ALERT SERVICE BULLETIN

412-14-160

MODEL AFFECTED: 412/412EP

SUBJECT: MAIN ROTOR DRIVE, ENGINE-TO-TRANSMISSION DRIVE SHAFT RETAINING NUTS INSPECTION/REPLACEMENT OF.

Figure 1. Main drive shaft attaching nuts (Part I).

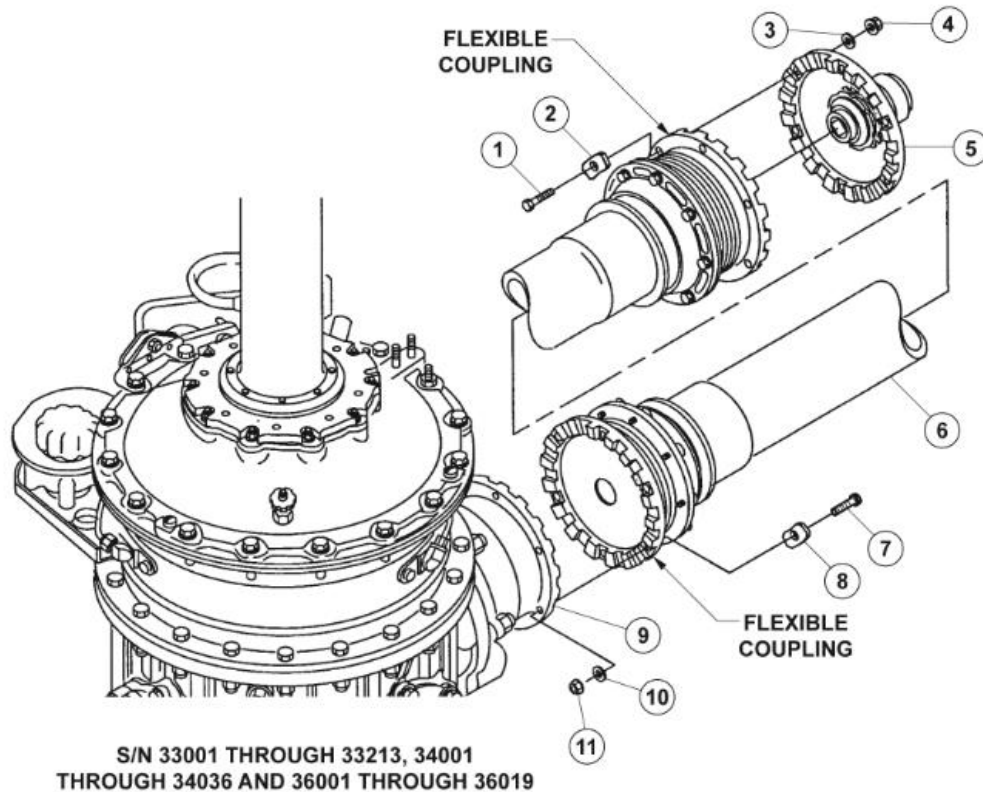
1. Gain access to the main drive shaft assembly and replace the main drive shaft attaching nuts (Figure 1) MS21042L5 with NAS9926-5L nuts (BHT-412-MM).
2. Make an entry in the helicopter logbook and historical service records indicating compliance with this Alert Service Bulletin.

Figure 2. Main drive shaft attaching nuts (Part II).

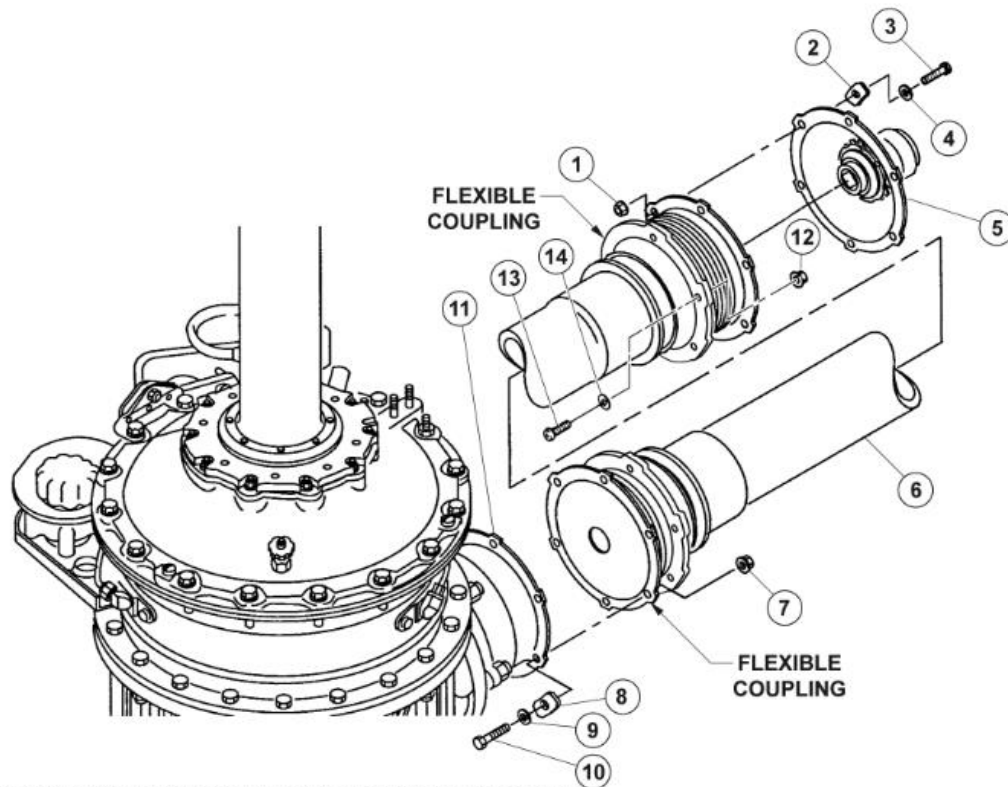
1. Gain access to the main drive shaft and replace the currently installed main drive shaft and main drive shaft attaching MS21042L4 or NAS9926-4L nuts (Figure 2, items 1, 7 and 12) with nuts P/N 90-132L4 (BHT-412-MM).
2. Make an entry in the helicopter logbook and historical service records indicating compliance with this Alert Service Bulletin Revision B.
